UNITED STATES PATENT AND TRADEMARK OFFICE

10/552,376

Office Action Summary	Application No. 10/552,376	Applicant(s) CHEN, HUA	
	Examiner Christopher Verdier	Art Unit 3745

FIG. 4

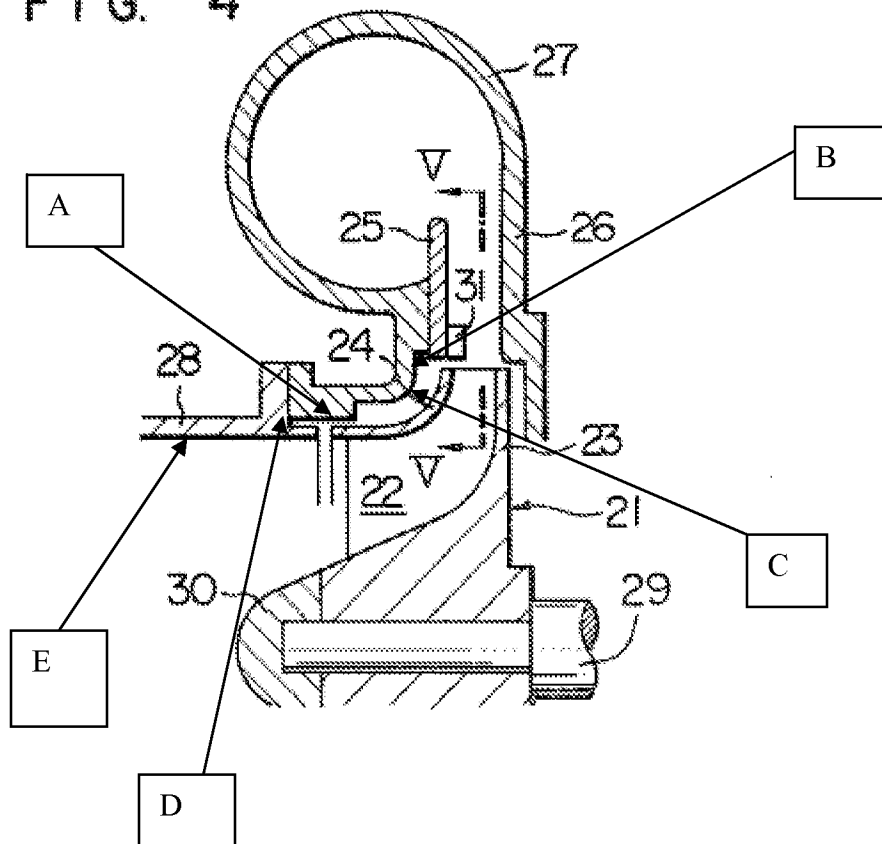
Claims 1, 4, 5, 6, 9, 11, 12/6, 13/6, 14/6, 15/6, 12/9, 13/9, 14/9, 12/4, 13/4, 14/4, 15/1, 15/4, and 15/11 are rejected under 35 U.S.C. 102(b) as being anticipated by Yoshinaga 4,395,197. Disclosed is a compressor comprising a compressor wheel 21 having a hub 1, compressor blades 22 and being mounted for rotation on a shaft 29, each blade being characterized by an outer edge, an upstream leading edge and a downstream trailing edge, and a shroud 27/28 mounted adjacent (note that adjacent does not require that two elements be immediately next to one another) and around the outer edges of the compressor blades and defining a gas flow path between the shroud and the hub from a compressor inlet to a diffuser outlet, through which the blades rotate with respect to the shroud, wherein in cross-section the shroud forms a surface A along the flow path, the surface being characterized by a profile that includes a relative discontinuity B in the region of the trailing edge, wherein the discontinuity forms a downstream-facing blocking face adapted to impede an upstream flow of gas between the shroud and the wheel, the blocking face extending across the flow path to form a sharp edge connecting the blocking face to a smoothly curving surface C along the gas flow path upstream of the discontinuity. The cross-section profile of the shroud surface along the flow path is further characterized by a second relative discontinuity D that is in the region of the leading

edge, wherein the second relative discontinuity forms a second downstream-facing blocking face adapted to impede an upstream flow of gas between the shroud and the wheel, the second blocking face extending across the flow path to form a sharp edge connecting the second blocking face to a second smooth surface E upstream of the second discontinuity. The second discontinuity is located upstream of the leading edge of the wheel blades. The second discontinuity is spaced from the leading edge of the wheel blades by a distance of the same order as the axial clearance of the trailing edge from the compressor housing. The or each downstream-facing blocking face comprises a planar surface cut into the curving surface. The second downstream-facing blocking face comprises a planar surface cut into the curving surface, and the planar surface is perpendicular to the axis of the shaft. The radial extent of the second discontinuity is of the same order as the radial clearance between the trailing edge and the housing. The sizes of the first and second discontinuities are closely similar. The shapes of the first and second discontinuities are closely similar. Concerning claim 15, the term “turbocharger” is recited in the preamble of the claim and has not been given patentable weight. A preamble is generally not accorded any patentable weight where it merely recites the purpose of a process or the intended use of a structure, and where the body of the claim does not depend on the preamble for completeness but, instead, the process steps or structural limitations are able to stand alone. See *In re Hirao*, 535 F.2d 67, 190 USPQ 15 (CCPA 1976) and *Kropa v. Robie*, 187 F.2d 150, 152, 88 USPQ 478, 481 (CCPA 1951). Note the annotated figure below.

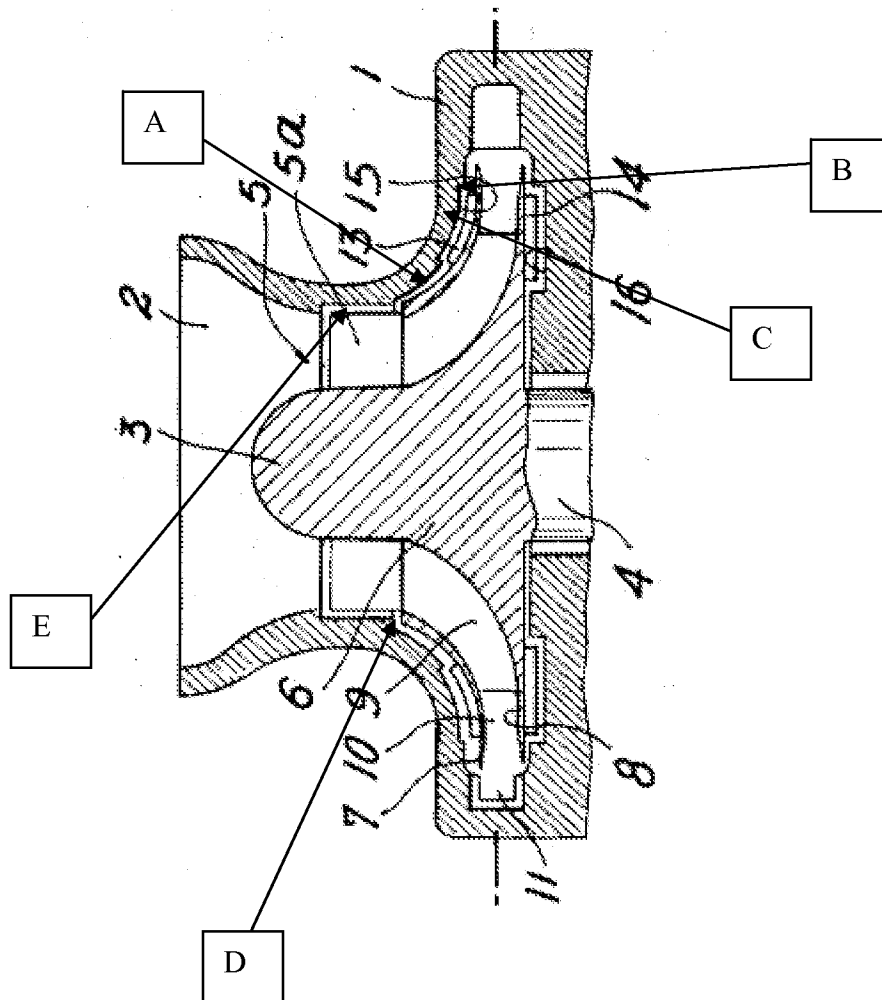
Claims 1, 4, 5, 9, 11, 13/9, 14/9, 13/4, 14/4, 15/1, 15/4, and 15/11 are rejected under 35 U.S.C. 102(b) as being anticipated by Fabri 3,824,029. Disclosed is a compressor comprising a compressor wheel 3/6 having a hub 3 and compressor blades 9 and being mounted for rotation on a shaft 4, each blade being characterized by an outer edge, an upstream leading edge and a downstream trailing edge, and a shroud 1 mounted adjacent (note that adjacent does not require that two elements be immediately next to one another) and around the outer edges of the

compressor blades and defining a gas flow path between the shroud and the hub from a compressor inlet to a diffuser outlet, through which the blades rotate with respect to the shroud, wherein in cross-section the shroud forms a surface A along the flow path, the surface being characterized by a profile that includes a relative discontinuity B in the region of the trailing edge, wherein the discontinuity forms a downstream-facing blocking face adapted to impede an upstream flow of gas between the shroud and the wheel, the blocking face extending across the flow path to form a sharp edge connecting the blocking face to a smoothly curving surface C along the gas flow path upstream of the discontinuity. The cross-section profile of the shroud surface along the flow path is further characterized by a second relative discontinuity D that is in the region of the leading edge, wherein the second relative discontinuity forms a second downstream-facing blocking face adapted to impede an upstream flow of gas between the shroud and the wheel, the second blocking face extending across the flow path to form a sharp edge connecting the second blocking face to a second smooth surface E upstream of the second discontinuity. The second discontinuity is located upstream of the leading edge of the wheel blades. The or each downstream-facing blocking face comprises a planar surface cut into the curving surface. The second downstream-facing blocking face comprises a planar surface cut into the curving surface, and the planar surface is perpendicular to the axis of the shaft. The sizes of the first and second discontinuities are closely similar. The shapes of the first and second discontinuities are closely similar. Concerning claim 15, the term “turbocharger” is recited in the preamble of the claim and has not been given patentable weight. A preamble is generally not accorded any patentable weight where it merely recites the purpose of a process or the intended use of a structure, and where the body of the claim does not depend on the preamble

See *In re Hirao*, 535 F.2d 67, 190 USPQ 15 (CCPA 1976) and *Kropa v. Robie*, 187 F.2d 150, 152, 88 USPQ 478, 481 (CCPA 1951). Note the annotated figure below.
